MEMORANDUM FOR: Docket File No. 40-8084

FROM: Gary R. Konwinski, Project Manager
Licensing Branch 2
Uranium Recovery Field Office, RIV

SUBJECT: AMENDMENT NO. 6 TO SOURCE MATERIAL LICENSE SUA-1119
FOR RIO ALGOM MINING CORP.

Figure 1 Water Level Monitoring Locations and Drawdown Contours Resulting from Pumping Well OMUT-9. Pumping period from 11-83 to 6-84.

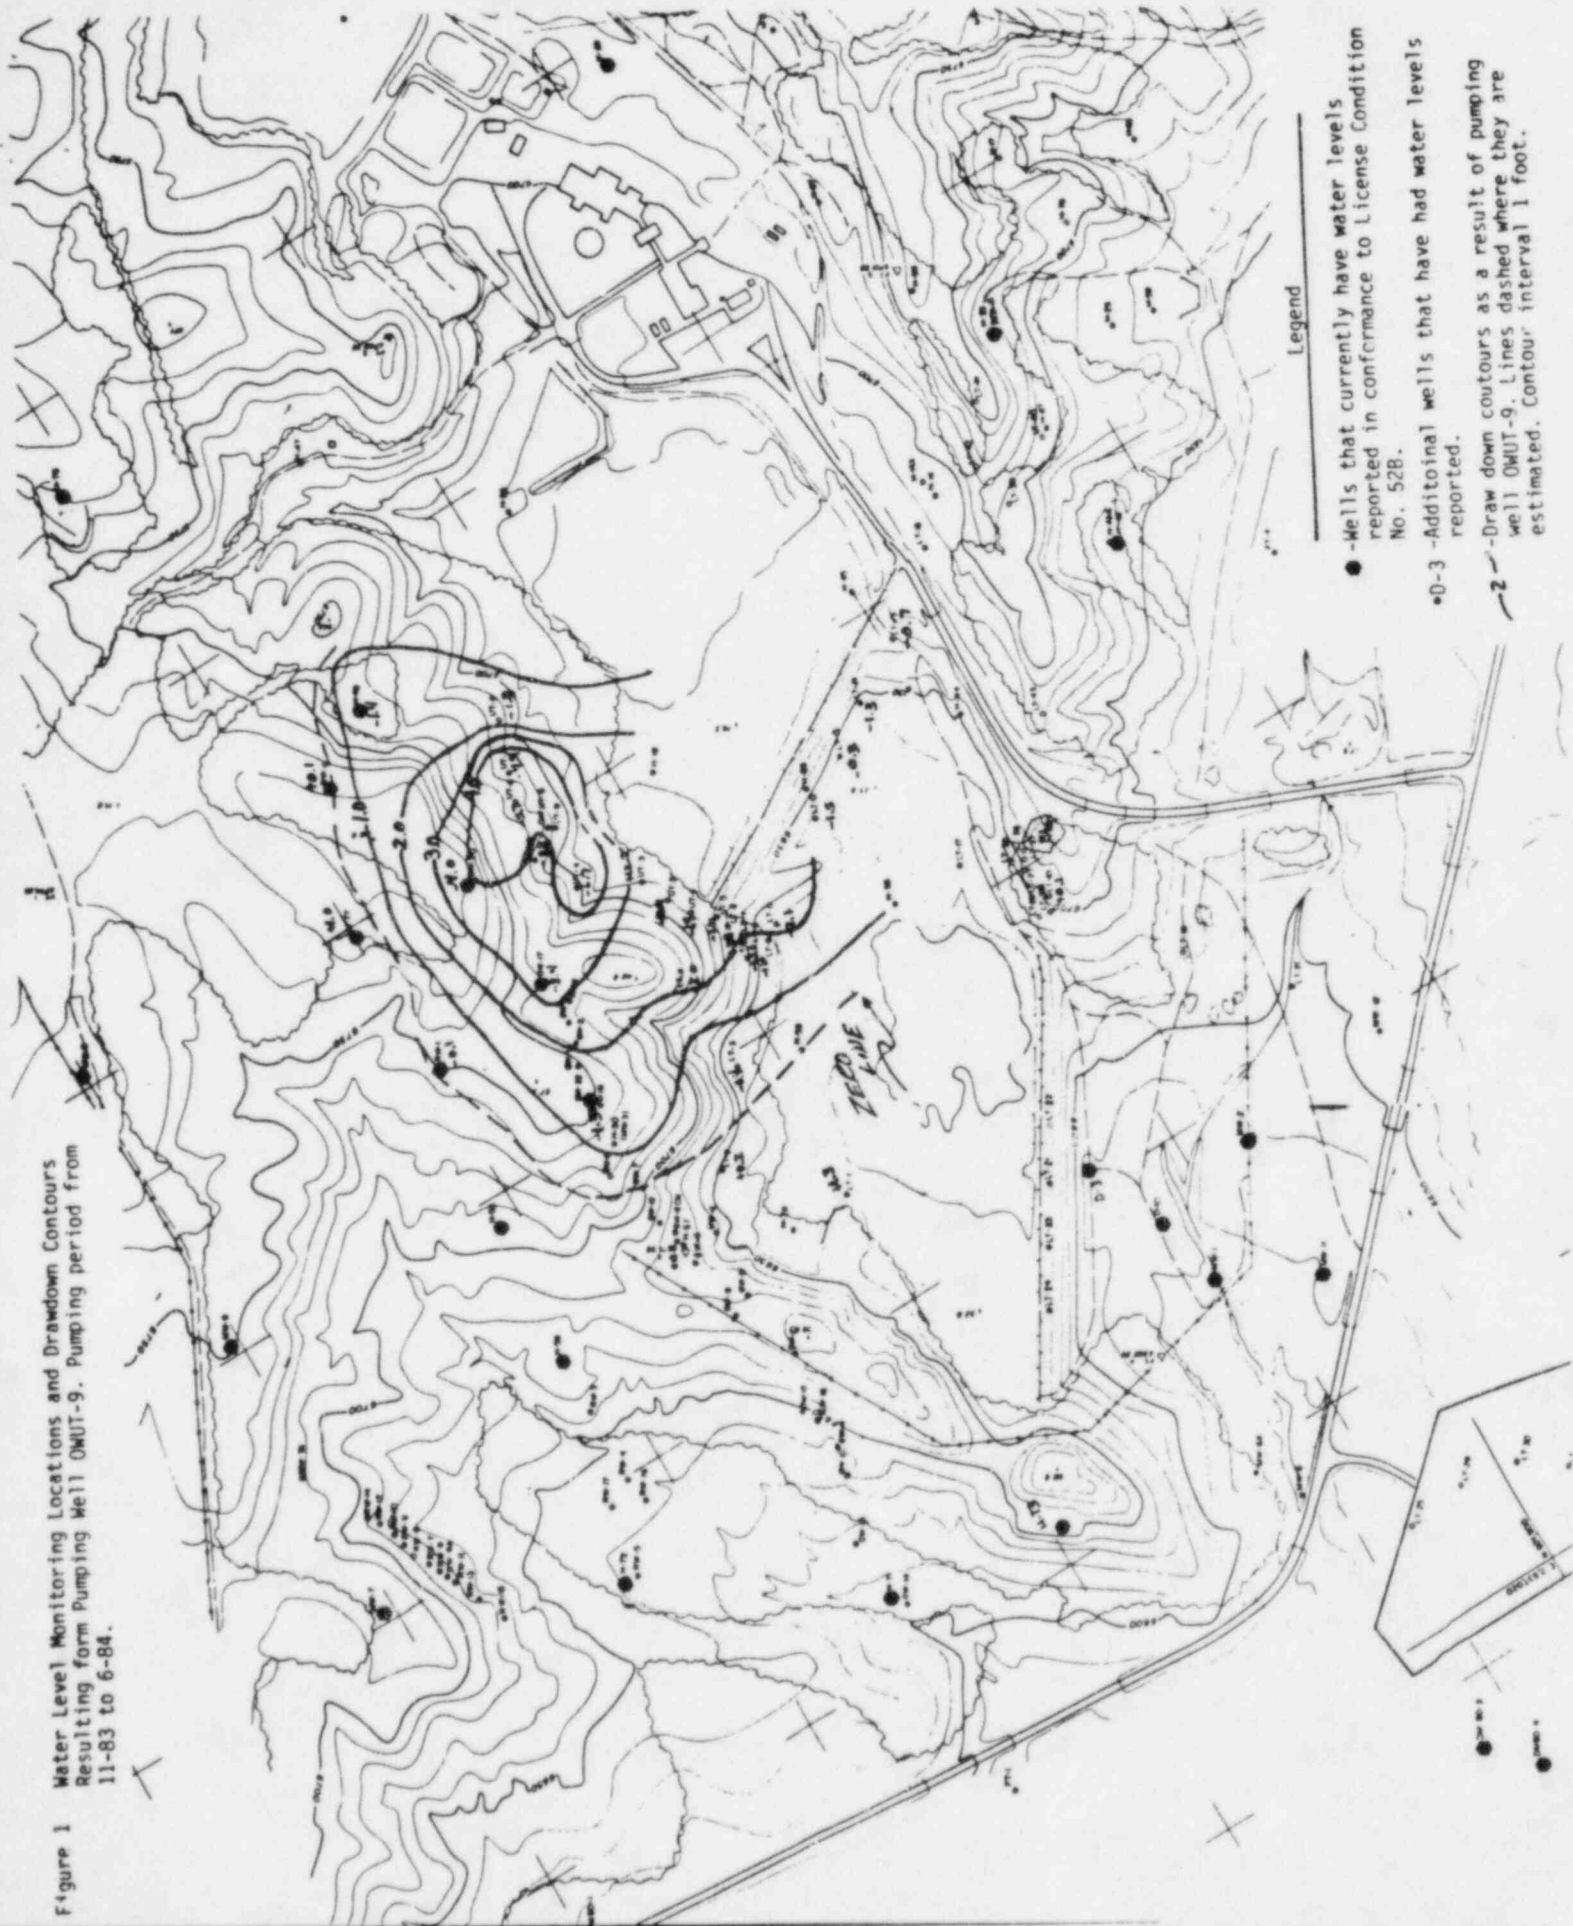
The water level data as shown in Table 1 was submitted in accordance with License Condition No. 52B of SUA-1119. Similarly, the potentiometric contour map, as submitted by Rio Algom, accurately depicted this data. However, because of the ground water divide which exists at the site and the location of the seepage recovery system, the water level data from the above wells is of little value in assessing the overall site potentiometric surface. A more useful set of water level data points could be derived from existing wells near the area of seepage recovery. Such data as compiled in Table 2 are more meaningful for assessing changes in the ground water system. These wells are located in the area of the successful pumping well - OWUT-9. As indicated by data from these wells and as shown in Figure 1, a cone of depression has been created in the vicinity of the pumping well. Figure 1 also shows locations of wells

which routinely have their water level reported to the NRC. Because sufficient water level data beyond June 1984 is not available, the current extent of the cone of depression is unknown. Assessing the cone of depression by recording water levels in adjacent wells yields valuable information for understanding the ground water system at this site and should continue to be reported.

Based upon the above discussion and the lack of current water level data for the wells in the area of the Well OWUT-9, the staff concludes that Rio Algom Mining Corp. should continue to measure water levels in the wells listed in Table 2. The staff further concludes that water levels from Wells H-18, UT-9, H-26, GW-21, GW-8, H-47, GW-23 and H-57 would add valuable data to determining the extent of the cone of depression developed by Well OWUT-9.

Therefore, pursuant to Title 10, Code of Federal Regulations, Part 40, Source Material License SUA-1119 is hereby amended by revising Licensing Condition No. 52 to read as follows:

- A. Radon monitoring shall be conducted continuously using passive monitoring devices which are exchanged and read at least quarterly.
 - B. The licensee shall implement a ground water monitoring and seepage control program as specified in the submittal dated September 21, 1984. In addition, the licensee shall collect and report water level data from the following:
MW Wells: 1, 2, 4, 5, 6A, 7, 8, 9, 10, 11 and 12;
H Wells: 38, 48, 49, 55, 56, 57, 71, 72, 73, 77 and 78;
LT Wells: 1 through 15; GW Wells: 17, 19 and 20;
RW Wells 1 and 2; UT Wells 1 through 8; D Wells 3 and 10;
and DM Wells 80-1, 80-2, 80-3 and 80-4.
